Addendum No. 2

Project Name:	DDSB Dunbarton HS	Date:	January 27, 2026
Description:	Steam Decommissioning	From:	Luigi Conforti
Address:	655 Sheppard Avenue Pickering, ON	Project No:	A0001060
Client Contact:	Pat Cook, DDSB		DDSB Tender No: T25-62

DUNBARTON HS
STEAM DECOMMISSIONING PH 1
REVISED DEMOLITION LAYOUT
ELECTRICAL

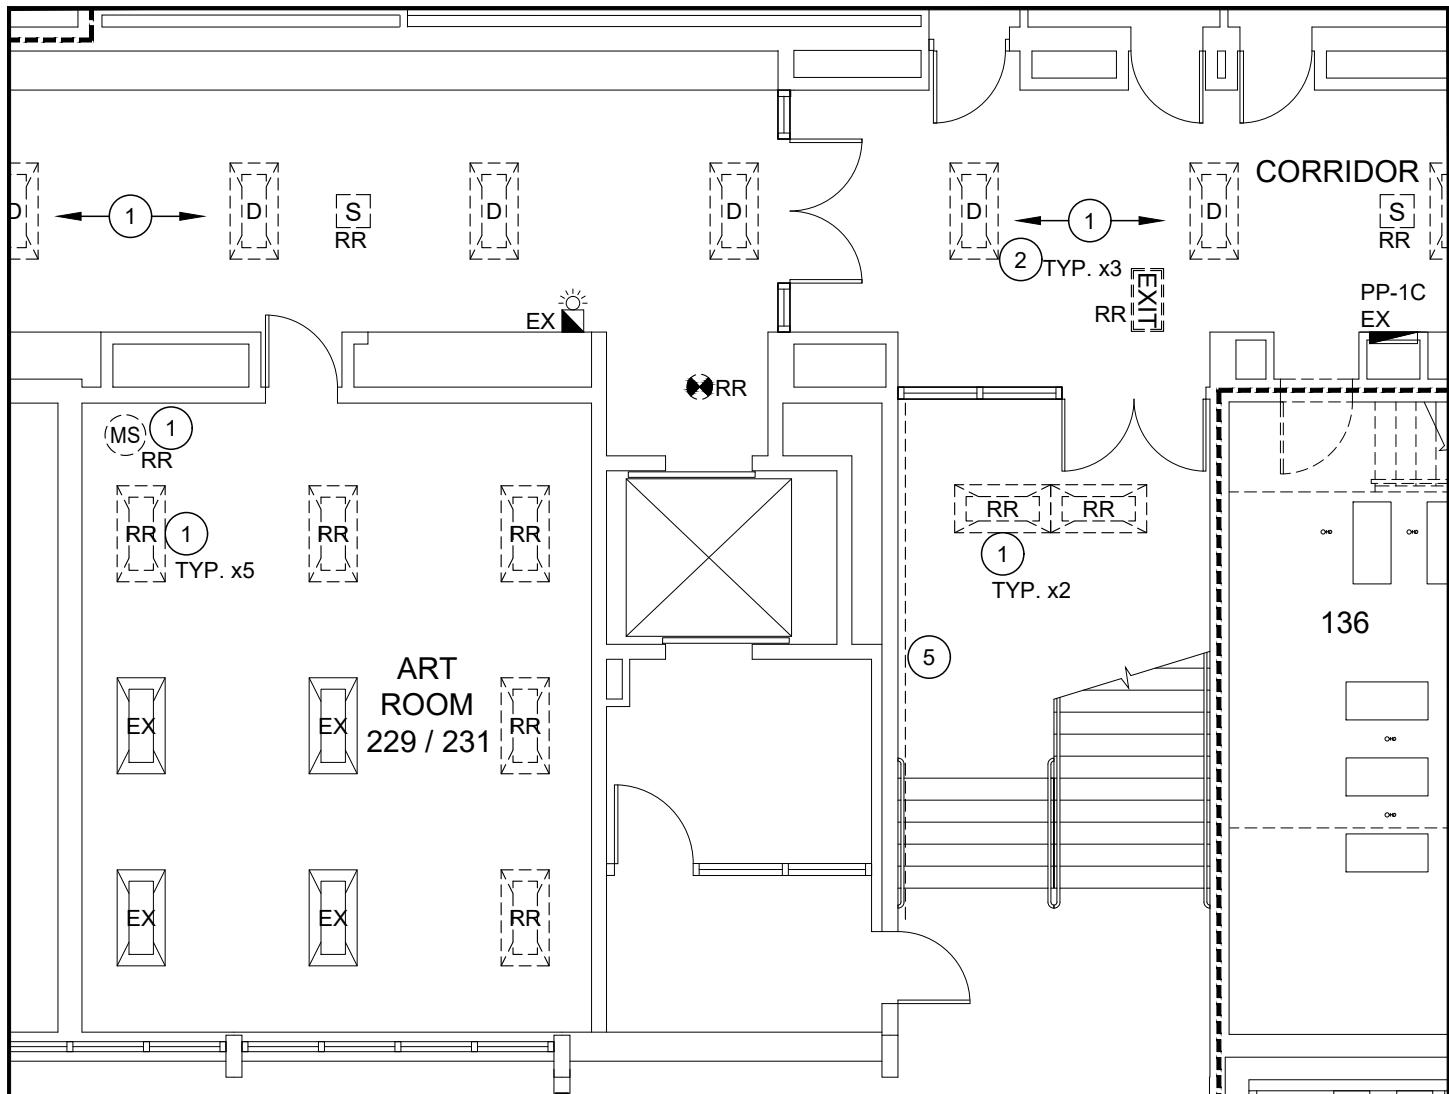
- .1 Delete Working Note 4.
- .2 See attached SK-E1 for clarification of re/re scope in Art Room 229/231 and lighting and conduit in stairwell to suit mechanical piping.

5 ALLOW FOR REWORK OF CONDUIT AND WIRING TO SUIT NEW MECHANICAL PIPING.
CONTRACTOR TO REVIEW AND COORDINATE WITH MECHANICAL ON SITE.

DUNBARTON HS STEAM DECOMMISSIONING PH 1 REVISED NEW LAYOUT

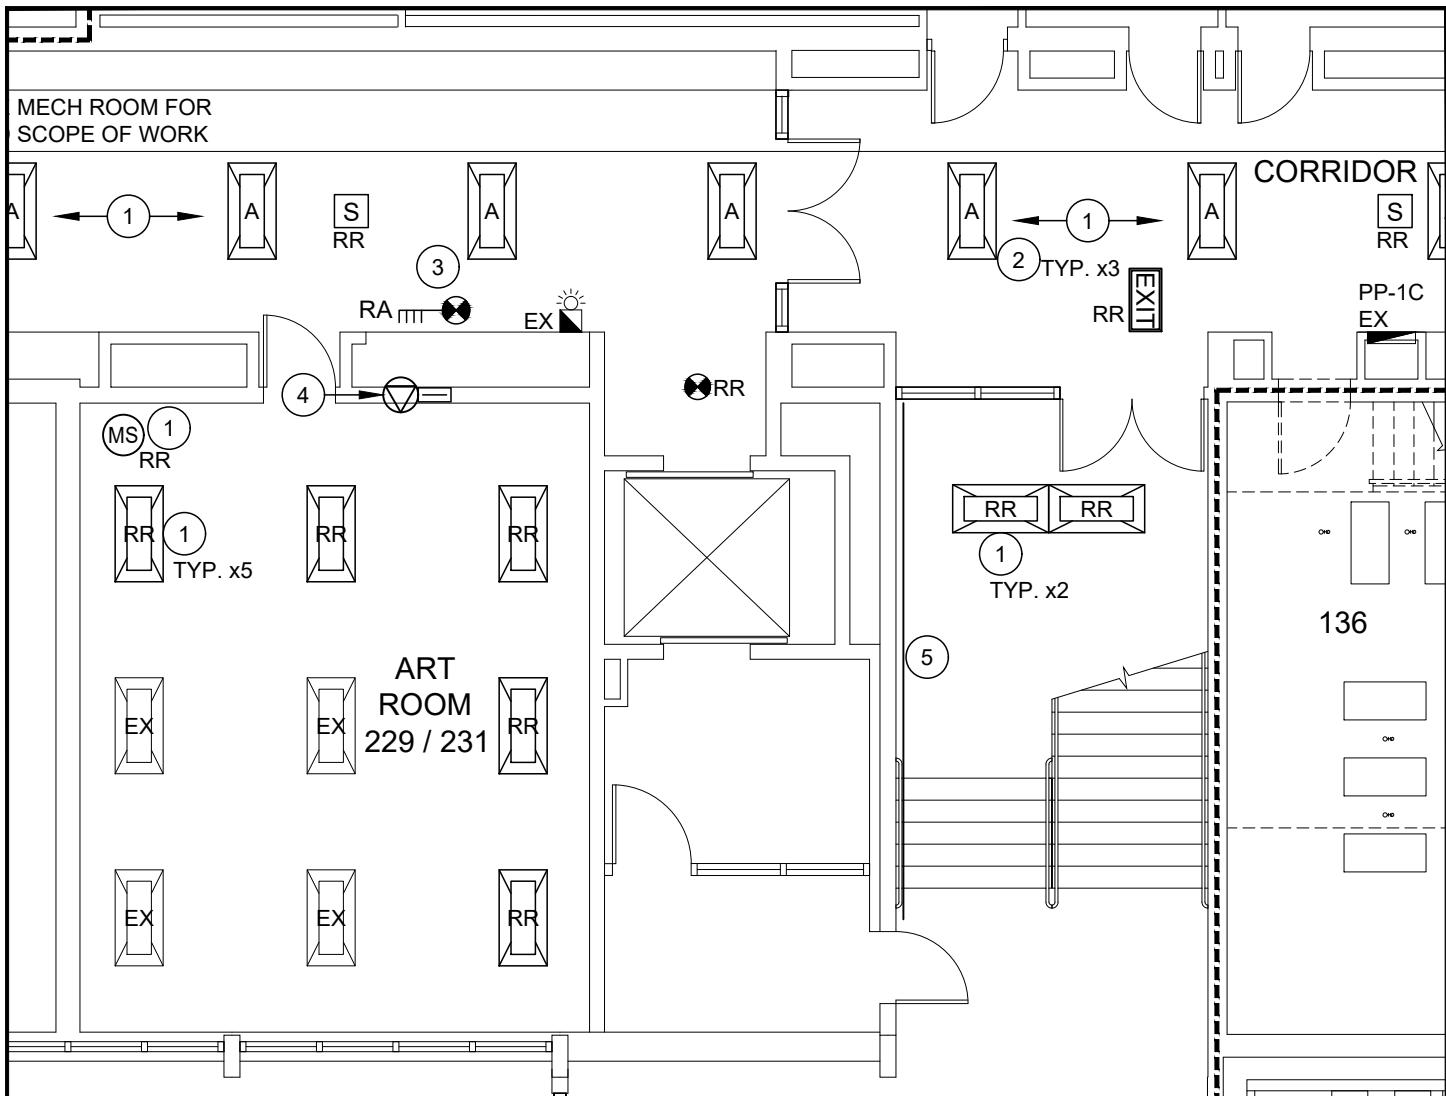
.1 See attached SK-E2 for clarification of re/re scope in Art Room 229/231 and lighting and conduit in stairwell to suit mechanical piping.

5 ALLOW FOR REWORK OF CONDUIT AND WIRING TO SUIT NEW MECHANICAL PIPING. CONTRACTOR TO REVIEW AND COORDINATE WITH MECHANICAL ON SITE.
